Meeting Date:
March 9, 2026

Request:
Conditional Use and Site Plan request for Western Reserve Academy for an addition to the Wang Innovation Center.

Hudson Planning Commission	CONDITIONAL USE/SITE PLAN REVIEW – WRA – WANG INNOVATION CENTER
Case No. 2026-72	March 9, 2026

Fig 3

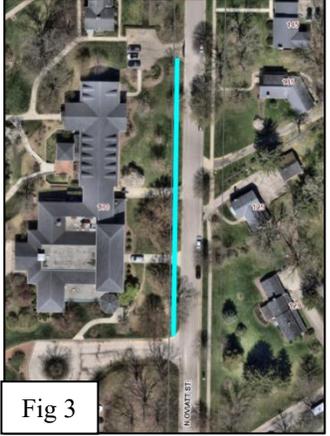
Staff Comment: Staff recommends sidewalks be installed along N Oviatt between the adjacent curb cuts to meet this requirement (see Figure 3).

1. Revise the civil drawings to incorporate stormwater improvements to the northern pond in order to be compliant with the requirements for retention/detention as stipulated in Section 1207.07.
2. Revise the civil drawings to include a sidewalk extension as depicted in Figure 3 of the staff report in order to be compliant with pedestrian pathways and linkages requirements of Section 1205.04(d)(11).
3. Further study tree and vegetation protection per the analysis on pages 7 and 8.
